COMANCHE PEAK STEAM ELECTRIC STATION
UNITS NOS. 1 AND 2

PROTECTIVE COATINGS
SPECIFICATION 2323-AS-31
APRIL 15, 1977
REVISION 1 - MARCH 15, 1978
REVISION 2 - MARCH 15, 1984

GIBBS & HILL, INC.
ENGINEERS, DESIGNERS, CONSTRUCTORS
NEW YORK, NEW YORK

EMERGENCY
AIR LOCK

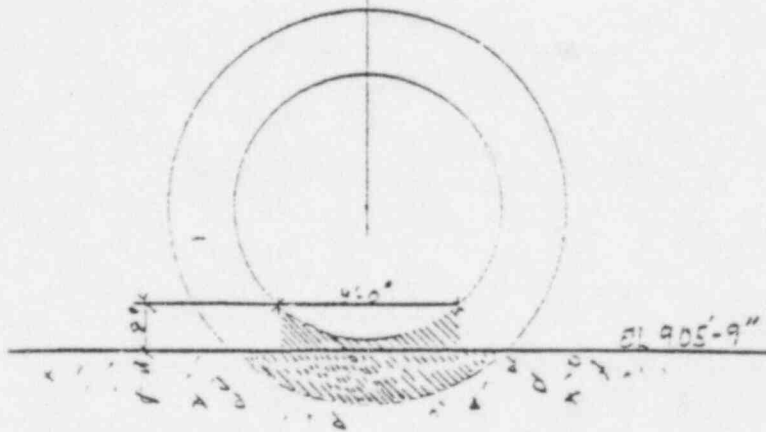
A. APPLICABLE SPEC/REQUIREMENT 2323-AS-31 REV. 1B. DETAILS Areas located on the lower portion of the Emergency Air Lock inContainment I and II are inaccessible for coating in accordance with the abovespecification. Request that the areas under question be removed from AS-31requirements. Sol: The shaded areas shown in Section A. and B. of Page 2 of thisDocument shall be coated under AS-30 guidelines, however, AS-31 coating shall be usedFOR OFFICE AND
ENGINEERING USE ONLY

HANGER * VAH-005-027-C82R	EL 912'
HANGER * VAH-005-028-C82R	EL 922'
HANGER * YAH-005-024-C82R	EL 931'

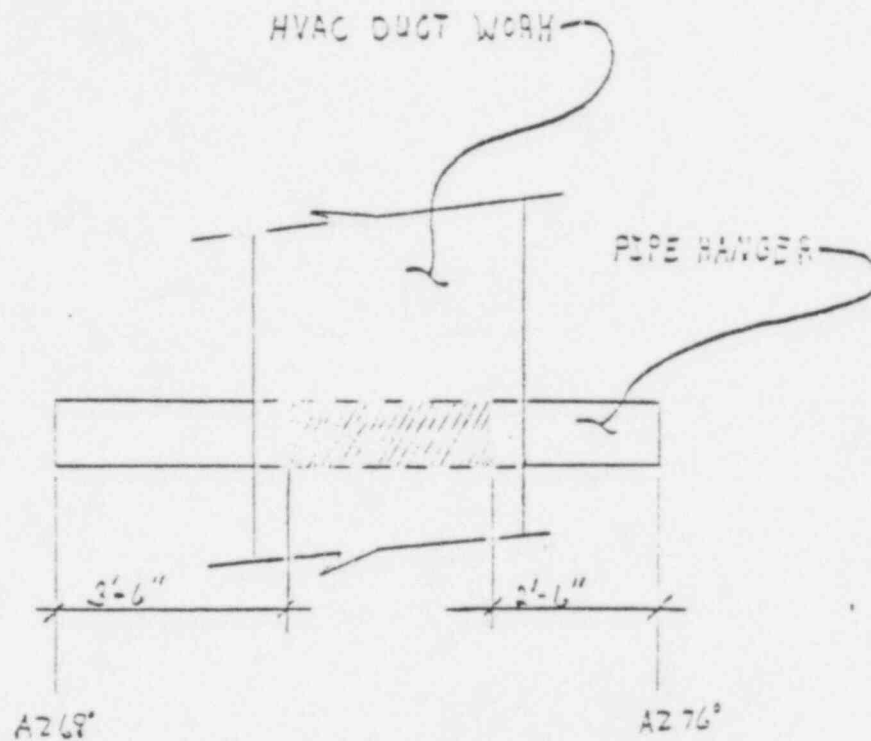
A. APPLICABLE SPEC/DWG/STANDARD 2320-AS-01 REV. 1B. DETAILS In Reactor I there are three pipe hangers which are located partially behind HVAC Ductwork rendering them partially inaccessible per section 1.1b of the above specification. The hangers are as follows: VA-1-005-027-C82R,VA-1-005-025-C82R, VA-1-005-024-C82R, and at elevation 912, 922 and 931 respectively.Request the inaccessible areas be coated on a best effort basis under AS-30.Sol: The inaccessible areas, shown as shaded areas on attached drawing, shall be removed from AS-31 coating and inspection requirements and coated on a best effort basis. All remaining portions shall be coated under full AS-31 requirements.
